भारत सरकार GOVERNMENT OF INDIA
रेल मंत्रालय MINISTRY OF RAILWAYS
रेलवे बोर्ड (RAILWAY BOARD)

No. 2008/Sig/36-SD/1/Pt (efile 3318369)

Sub: Hazard of point position not corresponding to the detection received in interlocking.

द.पू.म.रे S.E.C.R. मंडल रायपुर DIVN-RAIPUR	CHECKED BY			APPROVED	TITLE: POINT CONTROL CIRCUIT-104 TO SUIT DRG.NO. SI/R/BYL/2023/02 LOA NO:
	SSE/SIG/CON/R	SSE/TELE/CON/BIA	ASTE/CON/BIA	Dy. CSTE/CON/D/BSP

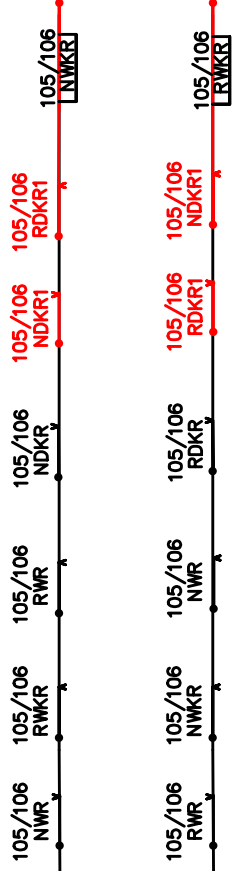
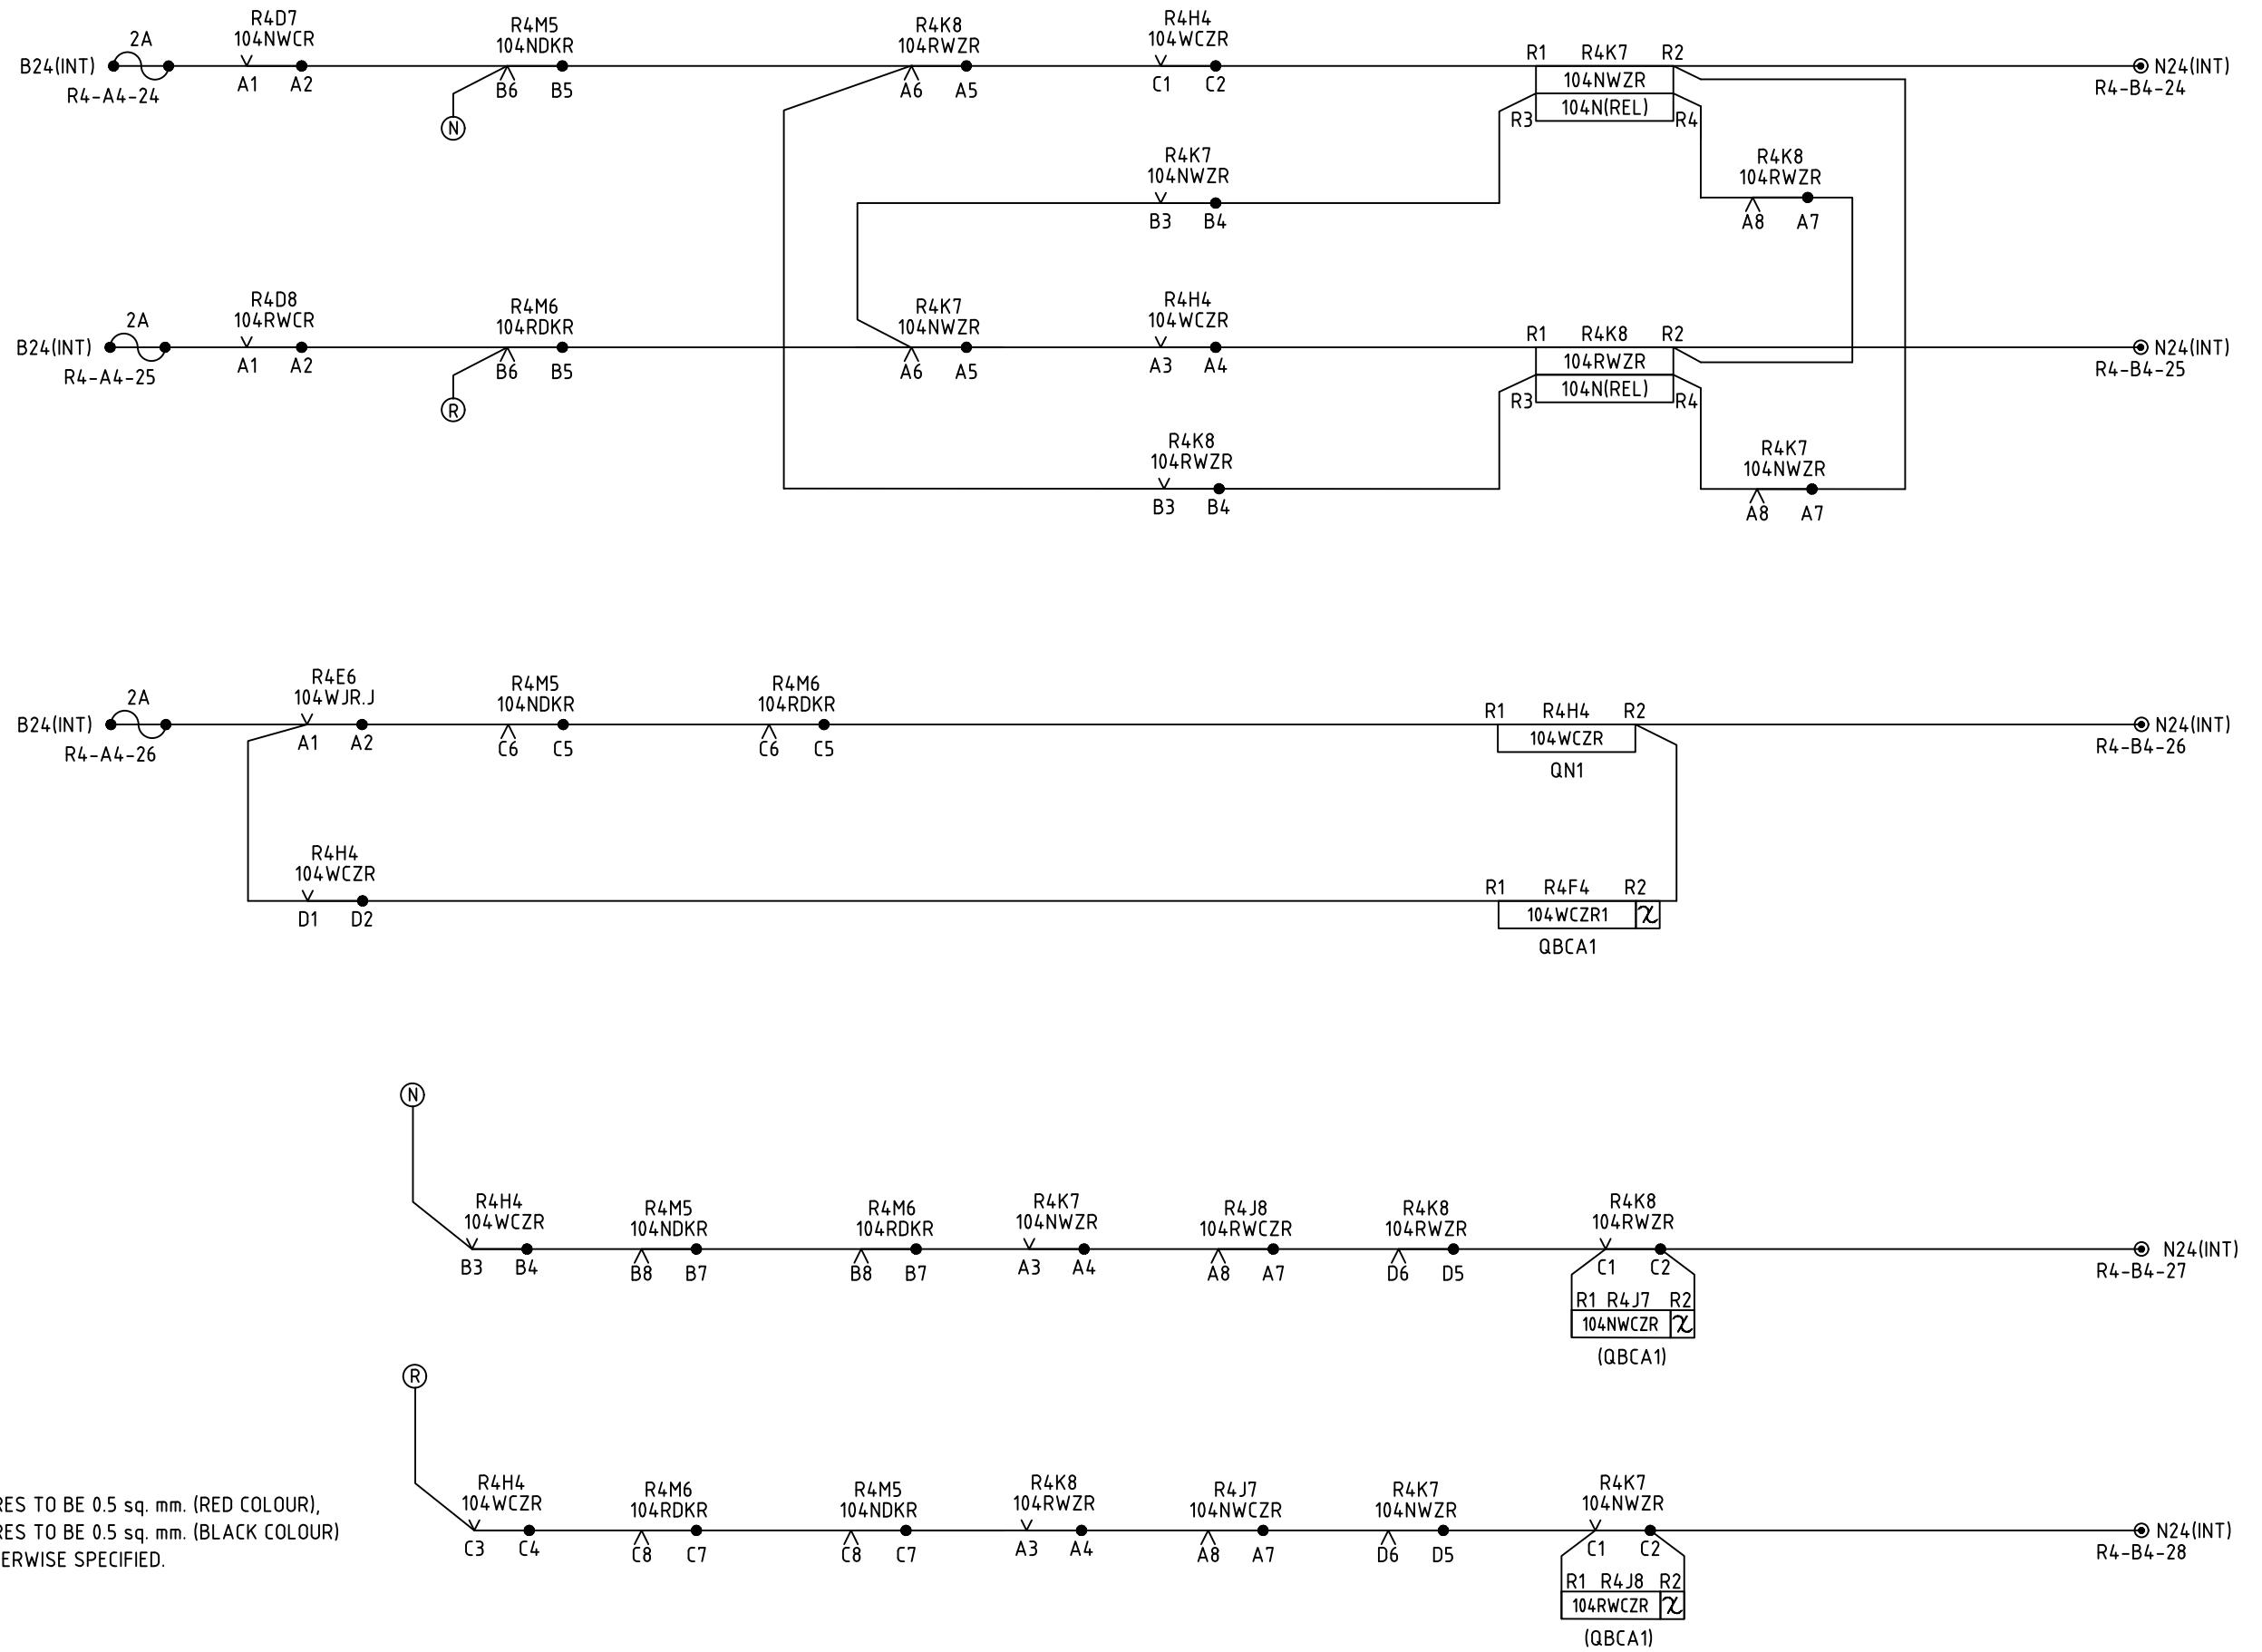
NOTE:-- EXISTING NDKR/RDKR FROM FIELD IS NOW SHOWN AS LOCAL FED WITH SINGLE CUTTING

NORMALLY PICKUP FCOR LOGIC

In connection with the proposed modified point circuits for "New bits NDKR1/ RDKR1 by direct proving of point detection and use of NDKR1 / RDKR1 in FCOR logic", the following is clarified:

- (i) The modified point circuit is to be implemented at all new Electronic Interlockings irrespective of the nos. of signal routes.
- (ii) For existing EI installations (irrespective of nos. of routes), zonal rlys are advised to draw an action plan for implementing the same in a time bound manner. Works may be proposed in Umbrella under PH33, if necessary.
